MIL-G-50678C (AR)
AMENDMENT 1
24 June 1991

MILITARY SPECIFICATION

GATE, MULTIPLE, CIRCUITS: 9342754

FIGURE 5. Multiple gate circuit test setup.

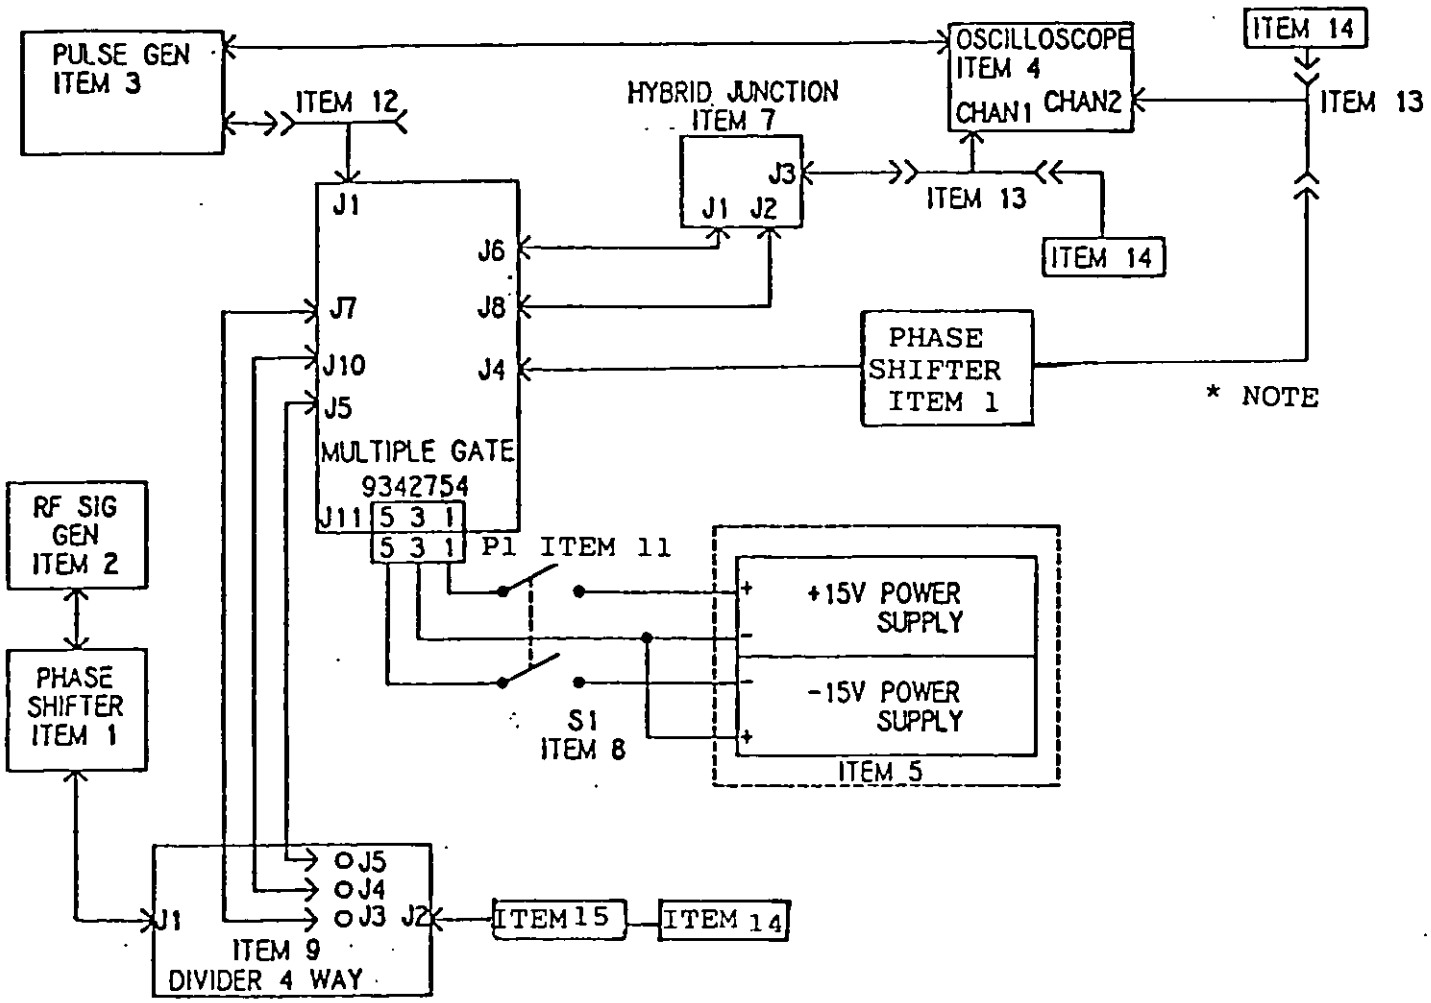
Add new paragraph 3.5.2.3.4 as follows:

"3.5.2.3.4 Gate Noise. With the multiple gate connected with the test setup as shown in Figure 5, a 60± 1% MHz signal and a monitored 2.8 V p-p signal per gate applied to J5, J7 and J10 of the unit under test, the amplitude of the algebraic sum of the Early Gate and Sum Gate signals during the Early Gate period shall be less than 1.0 V p-p. The amplitude of the algebraic sum of the Late Gate and inverted Sum Gate signals during the Late Gate period shall be less than 1.0 V p-p."

Add Figure 5. enclosed (page 6A).

Add new paragraph 4.7.3.4.4 as follows:

"4.7.3.4.4 Gate noise. Connect the unit under test to the test setup per Figure 5. Adjust channel 2 Phase Shifter so that the Early Gate on channel 1 is 180° out of phase with the Sum Gate on channel 2. Adjust variable gain on channel 2 for equal amplitude waveforms on channels 1 and 2. Place oscilloscope in channel 1 and 2 algebraic add function and readjust channel 2 phase shifter for Early Gate null. Resultant waveforms in the Early Gate shall be less than 1.0 V p-p. Place oscilloscope channel 2 in invert mode. Readjust amplitude and phase for Late Gate null. Resultant waveforms in the Late Gate shall be less than 1.0 V p-p."
